# Technical Note 1: Highways

Project: Dobroyd Mill, Jackson Bridge / Hepworth,  
West Yorkshire

31 July 2017

This Technical Note has been written in response to comments made by Kirklees Metropolitan Council's (KMC) Highways Officers on planning application reference 2017 / 90620. The document was not dated nor is it annotated except by headings and the pages (6 no.) are not marked. Reference is therefore made to the pages (1 to 6 in the Word document) and headings as appropriate. The said document is attached to this Technical Note.

FIGURE 3  
 FLOW DIAGRAMS

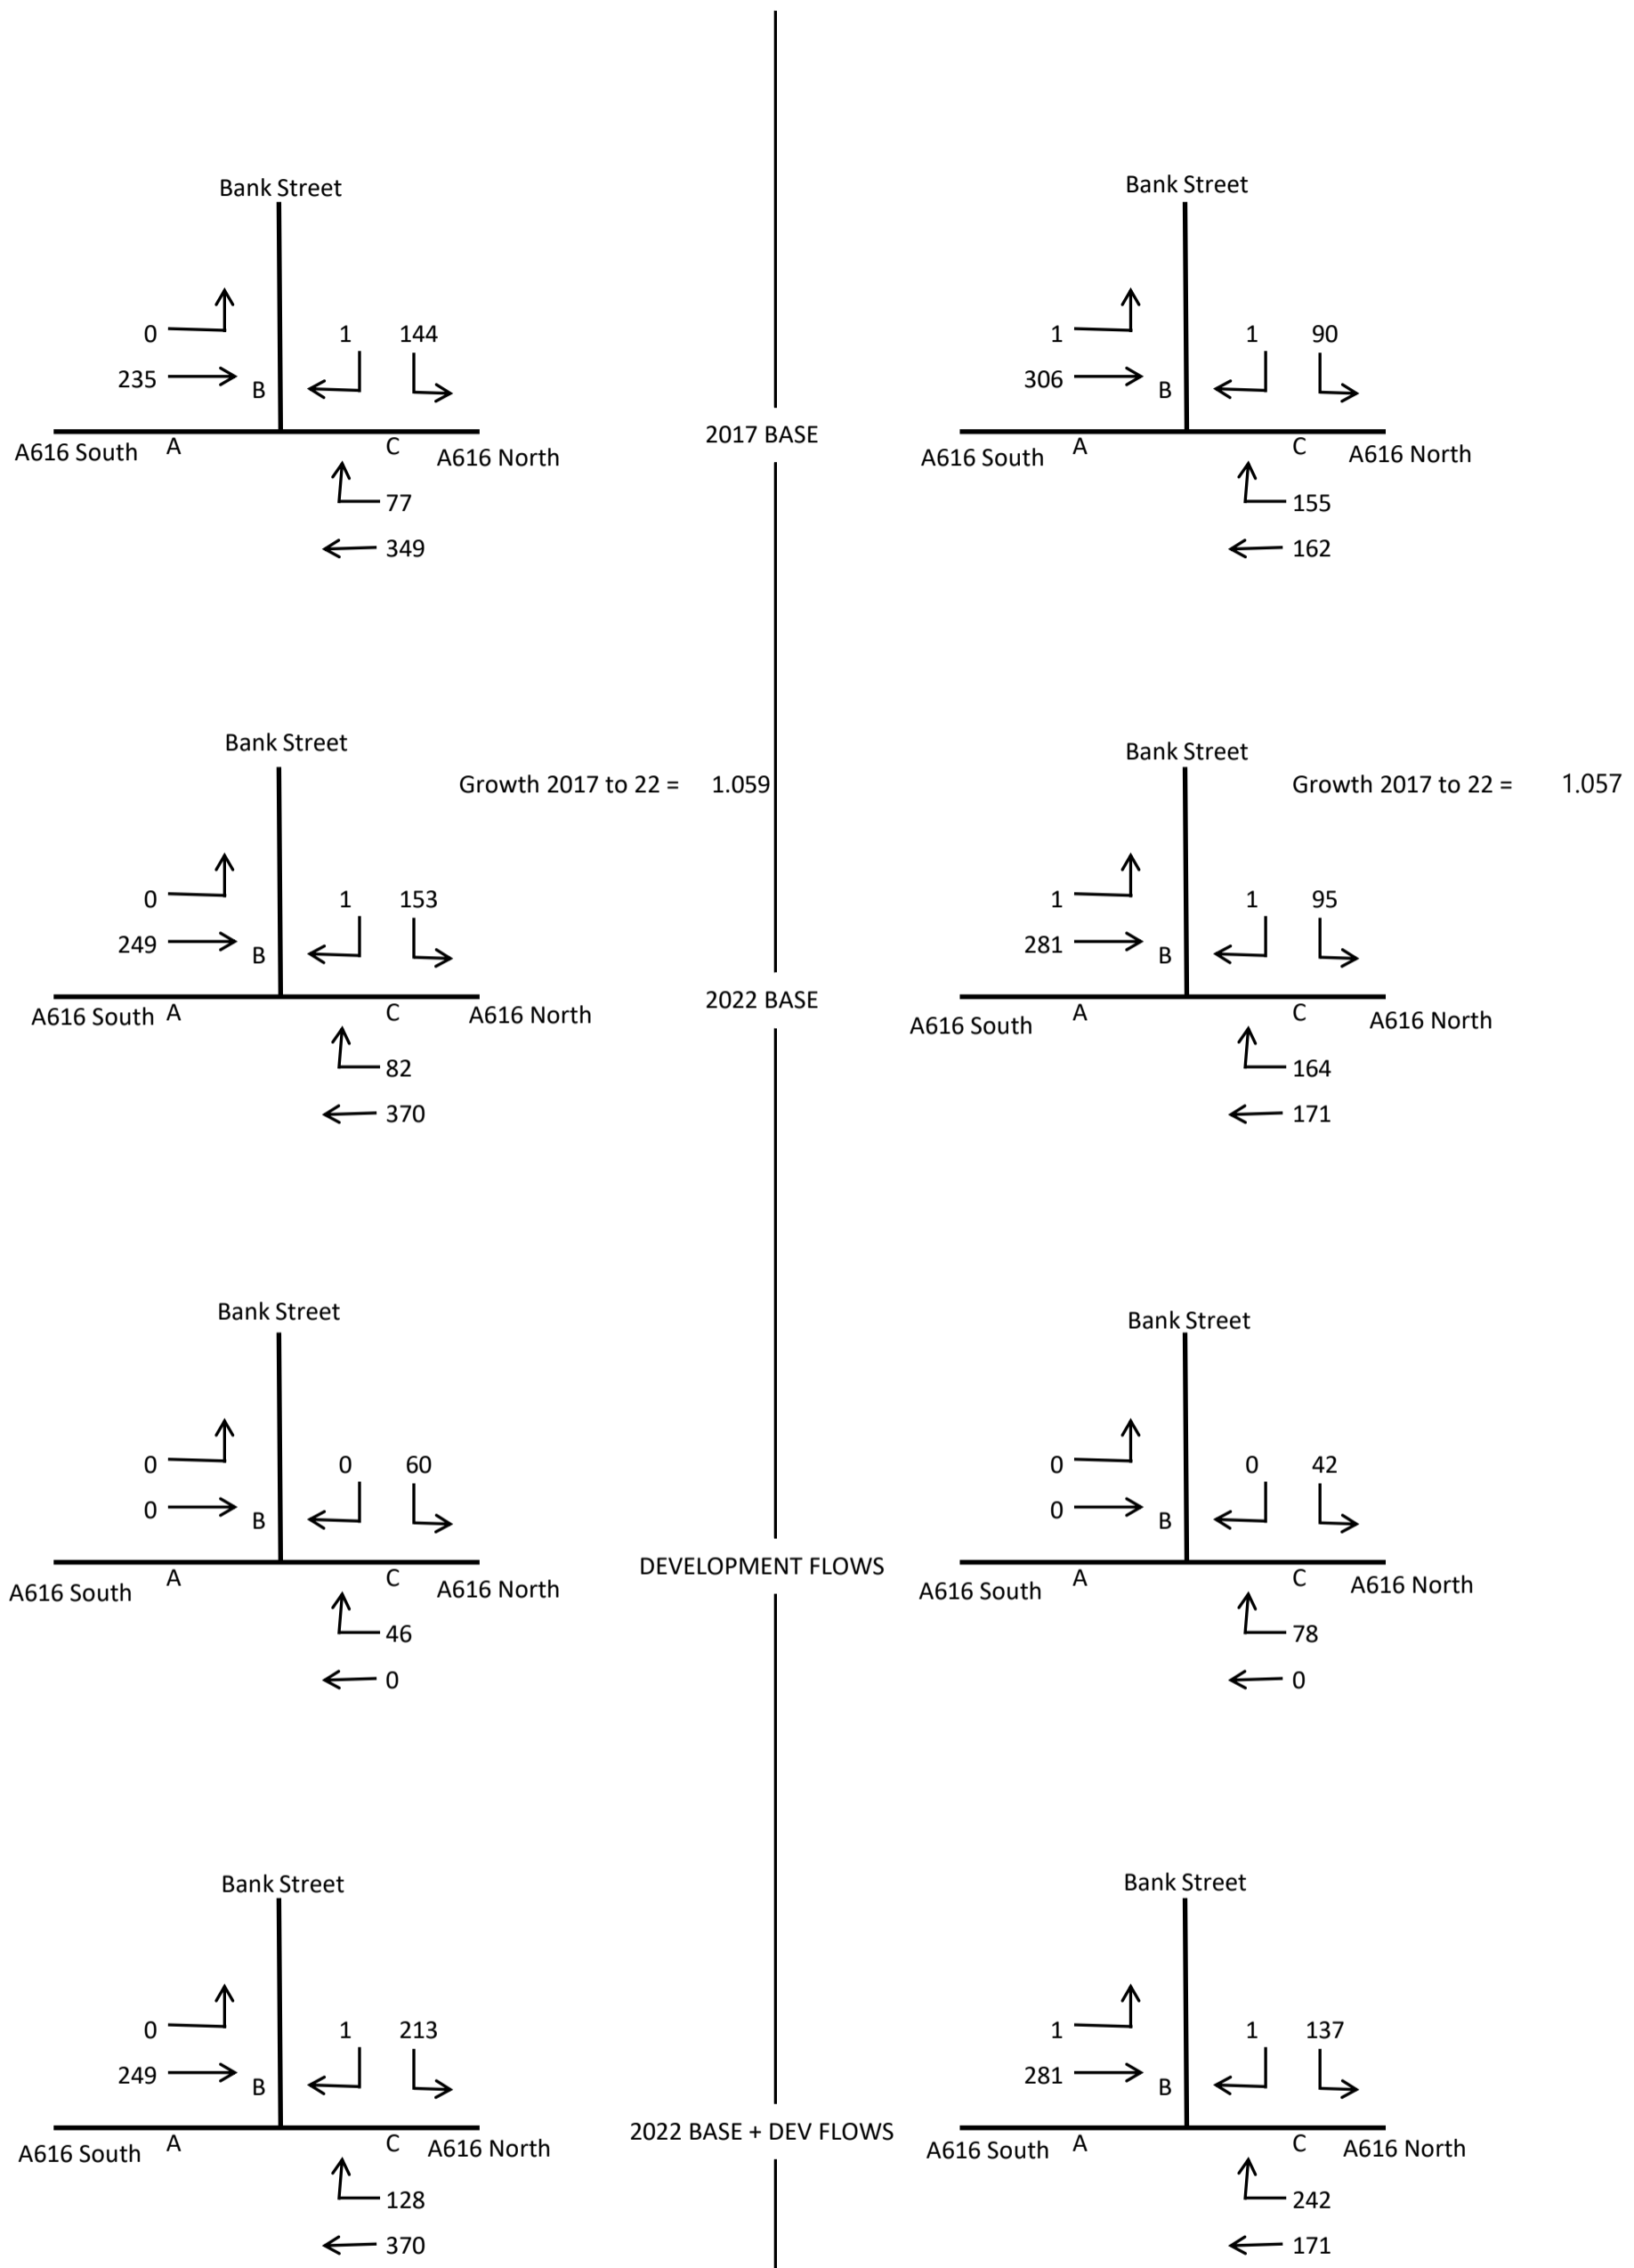
The Summary on **Page 5** clarifies that the Bank Street junction in need of a PICADY assessment is the one with the A616 Sheffield Road. A peak period traffic survey has been undertaken to establish the turning movements at this junction. Tempro 7.2 has been used to determine the potential growth factors to a future design year (2022 has been used in this instance being application year plus 5 years) in the area as being 1.0591 and 1.0571 in the AM and PM peak periods respectively.

We have then used the predicted development flows (increased to take account of the revised restaurant TRICS rates) and added those in full with no discounting for existing traffic movements from the development site on to this junction. In addition, as a worst case we have assumed that all the traffic from the development would use this junction (there are other alternate routes that people will take to a variety of destinations) and that there is a 10% heavy goods vehicle content in the turning movements (actually significantly less).
